STATE OF MARYLAND CRITICAL AREA COMMISSION CHESAPEAKE AND ATLANTIC COASTAL BAYS

July 14, 2006

Bonney Property

S 99-009, P 05-0022

RESUBDIVISION OF LOT BONNEY PROPERTY 1 OF 2

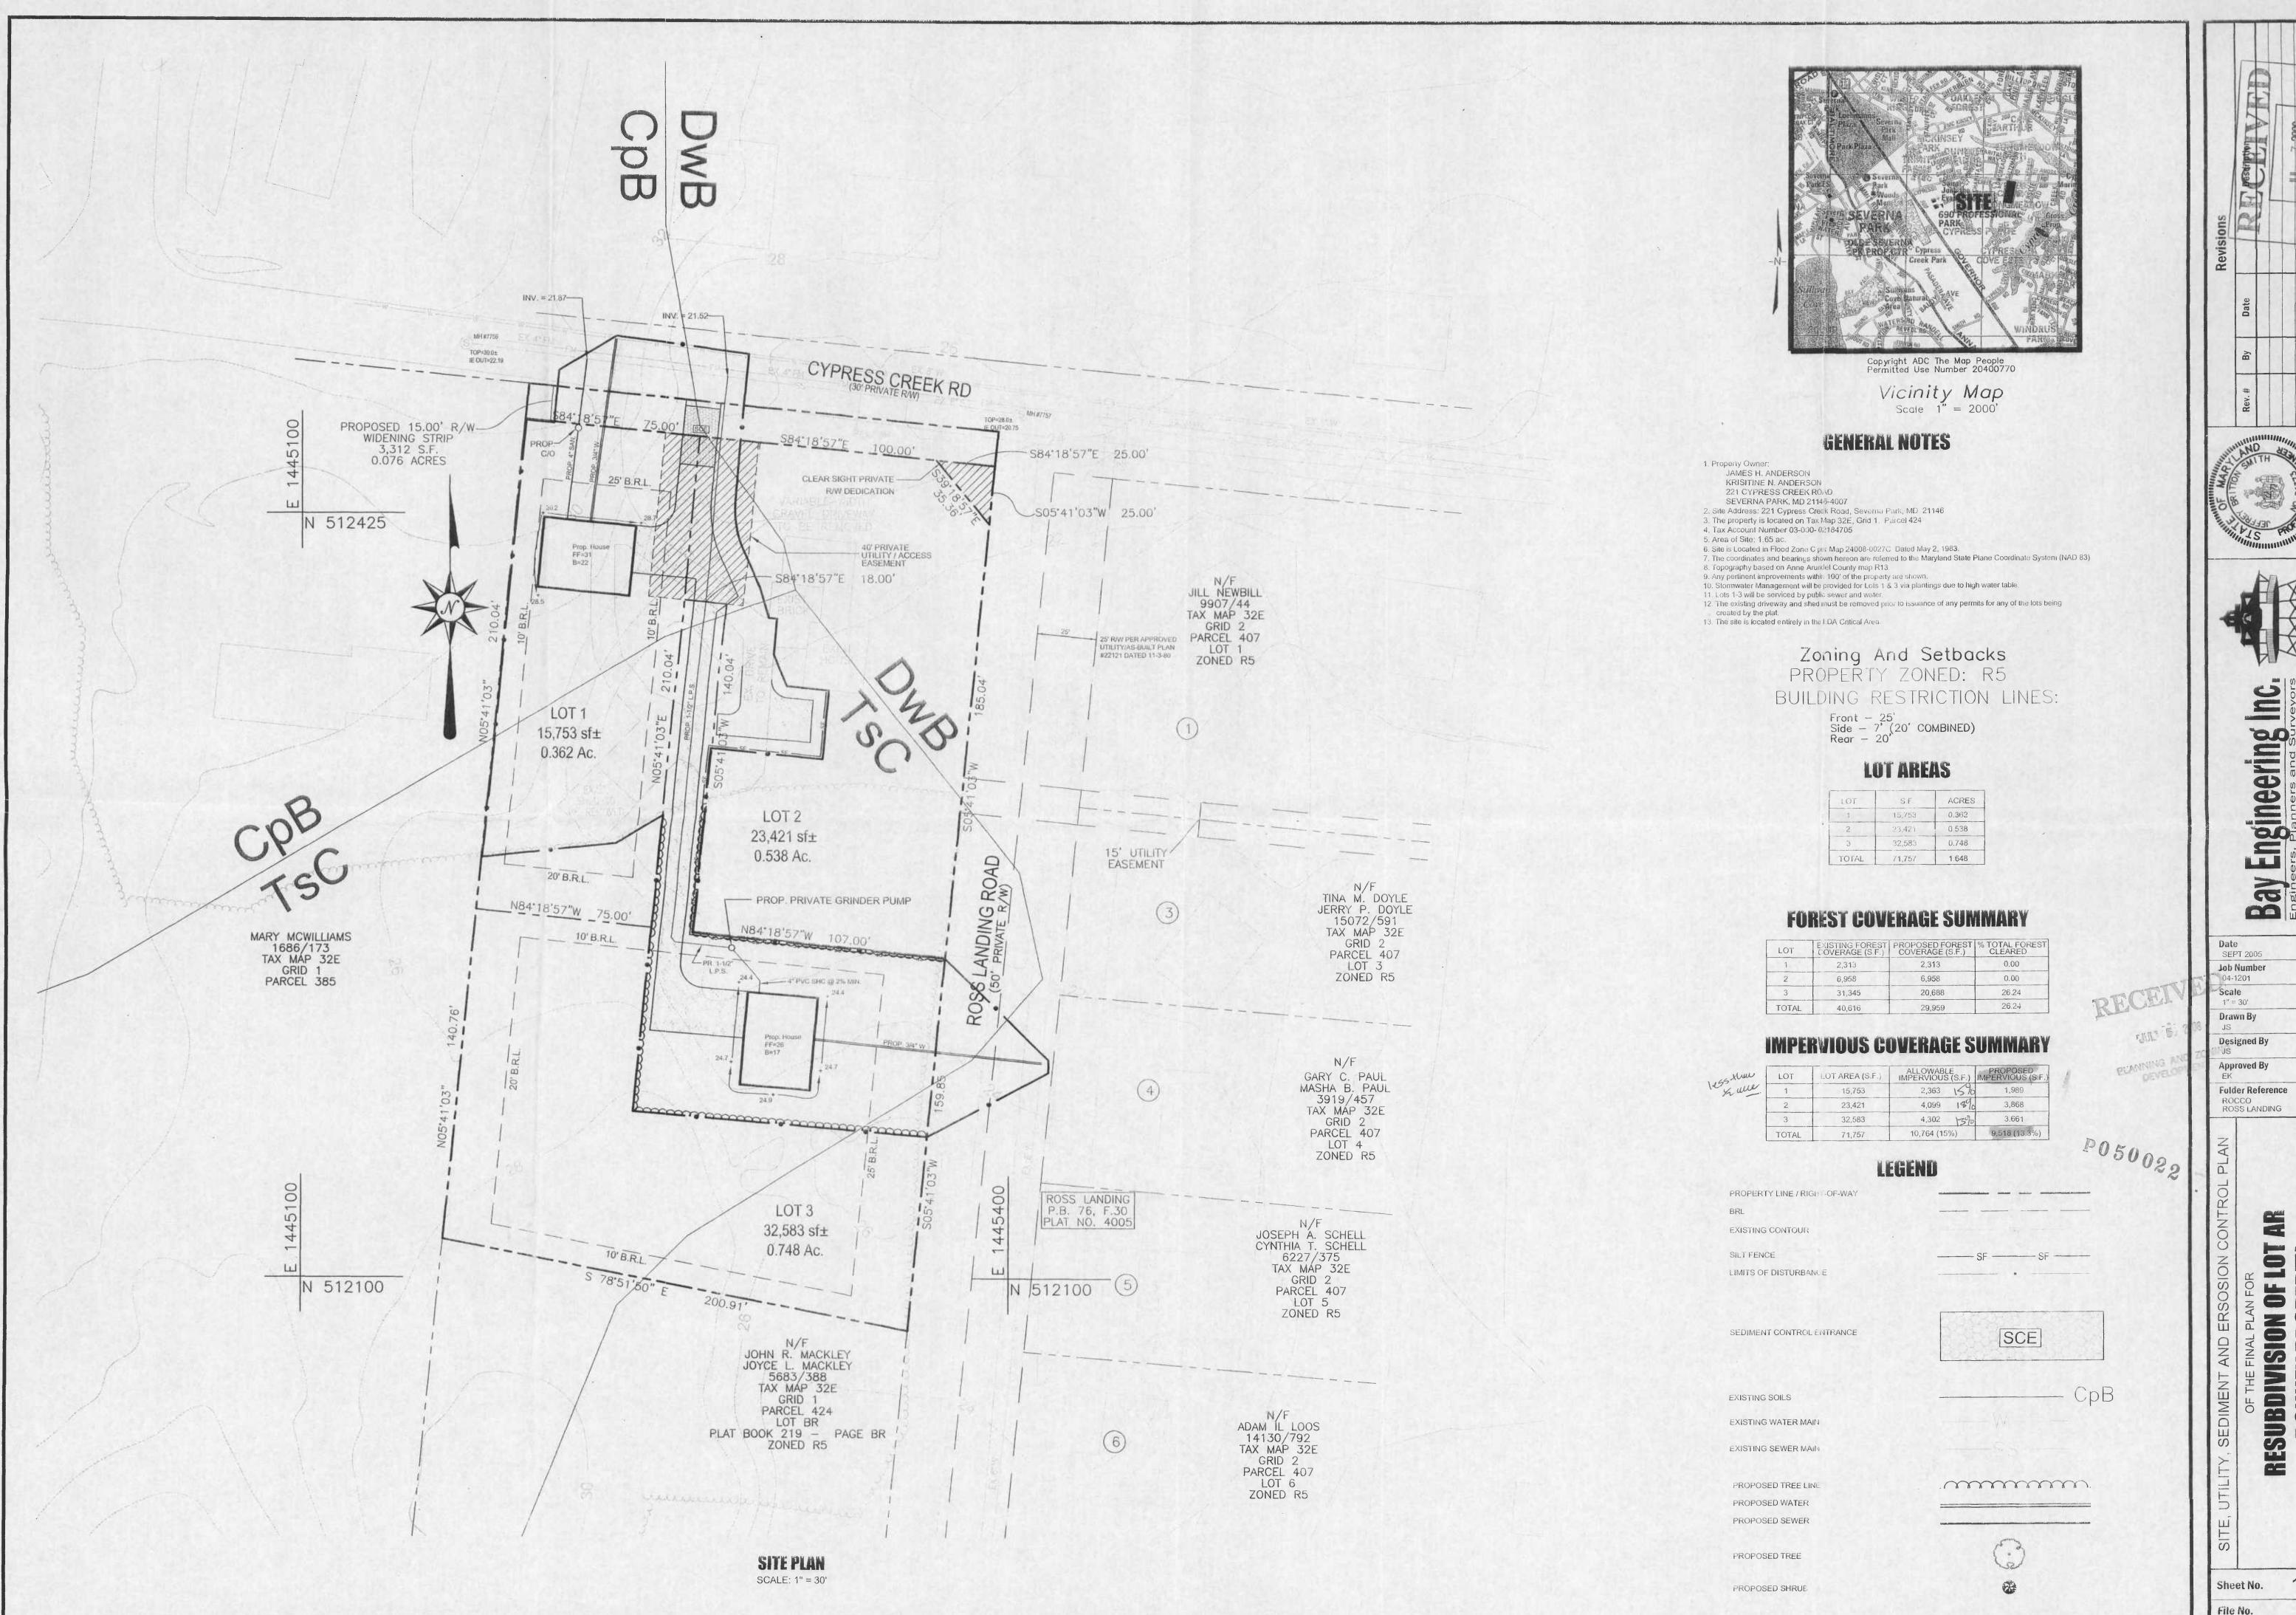
- 1. The impervious surface chart on the plat has not been corrected. It should match the corrected impervious surface chart that appears on the Site, Utility, Sediment and Erosion Control Plan.
- 2. The total proposed impervious area listed on the impervious surface chart is 9,518 square feet: however on sheet 2 of 2 under the description of lot areas, the proposed impervious surface coverage total is listed as 9,293 square feet. These numbers need to match.
- 3. Since the amount of clearing on proposed lot 3 could change at the grading permit stage, we recommend that a note be added to the plat indicating the maximum allowable clearing, in order to avoid clearing above 30%.

- 2. The impervious coverage summary must be changed. While lots less than one acre are permitted up to 25% coverage, the total area of the subdivision is restricted to 15% impervious coverage. The table is misleading in that it lists each lot as having an allowable coverage up to 25%; however, if each future homeowner were to use their 25% allotment, the impervious coverage over the entire subdivision would exceed 15%. We recommend the applicant change the information in this summary so it is clear how much each lot is allotted to that the allowable impervious coverage column actually adds up to 10,764 square feet (15%).

- 3. The impervious coverage summary needs to include the impervious area created by the driveway.
